Access Compliance Report

Public Rights-of-Way

(Curb Ramps)

Intersection ID: 19869	Main Street: ARCHDALE_DR	Cross Street: CHERRYCREST_LN	Location: NE
ADA ID: FFCB248827FA	Ramp Type: BlendTrans2	Initial Pass/Fail: Fail	Overall Compliance: No
Severity Score: 21.25			
Codes/Mitigation Info/Possible Solution		Field Measurements/Component Compliance

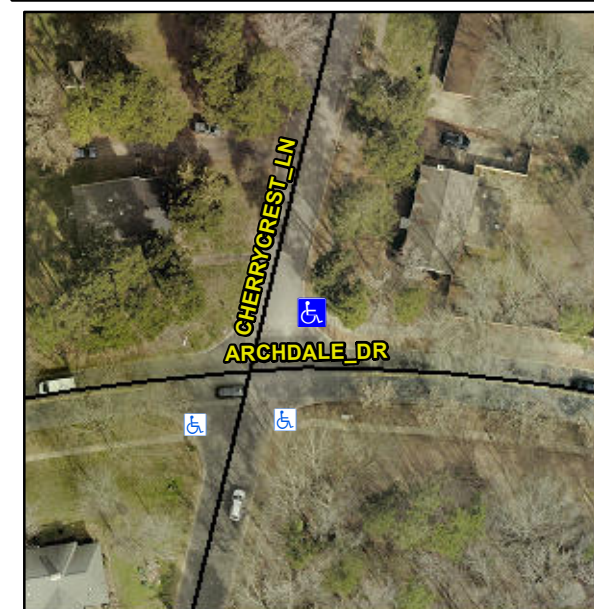
Not Found, R304.5.1, R304.5.3

Compliance	Description	Data	Compliance	Description	Data
N/A	Ramp Length (in)	113.0	Yes	BlendTrans Slope (%)	1.6
No	Ramp Width (in)	47.0	No	BlendTrans XSlope (%)	6.9
N/A	Flare Type LT	N/A	N/A	Flare Type RT	N/A
N/A	Flare Slope LT (%)	N/A	N/A	Flare Slope RT (%)	N/A
N/A	Flare Traversable LT?	N/A	N/A	Flare Traversable RT?	N/A
N/A	Landing Length (in)	N/A	N/A	DWS Provided?	N/A
N/A	Landing Width (in)	N/A	N/A	DWS Contrast?	N/A
N/A	Landing Slope (%)	N/A	N/A	DWS Length (in)	N/A
N/A	Landing X Slope (%)	N/A	N/A	DWS Full Width?	N/A
N/A	Landing Curb? (Y/N)	N/A	N/A	DWS Offset (in)	N/A
N/A	Shared Landing?	N/A			
N/A	Gutter Ponding?	N/A	N/A	Gutter Slope (%)	N/A
N/A	Gutter Lip Ht (in)	N/A	N/A	Gutter X Slope (%)	N/A
N/A	Painted X Walk1?	No	N/A	Painted X Walk2?	No
	X Walk 1 Direction	To W		X Walk 2 Direction	To S
	X Walk 1 Width (in)	N/A		X Walk 2 Width (in)	N/A
	X Walk 1 Slope (%)	3.9		X Walk 2 Slope (%)	5.3
	X Walk 1 X Slope (%)	5.4		X Walk 2 X Slope (%)	4.0

N/A	Ramp inside XWalk1?	N/A	N/A	Ramp inside XWalk2?	N/A
	Road Slope (%)	4.8		Clear Space?	N/A
	Road X Slope (%)	5.0	N/A	Clear Space to XWalk (in)	N/A
N/A	Any Obstructions?	N/A	N/A	Storm Grate/Utility Hazard?	N/A
	Obstruction Type			Storm Grate/Utility Type	
		N/A			N/A
			Yes	Surface Condition? (G/P)	Good
			No	Curb Slope (%)	11.9

Remove & Replace Curb Ramp With Two New Directional Ramps or Equivalent.
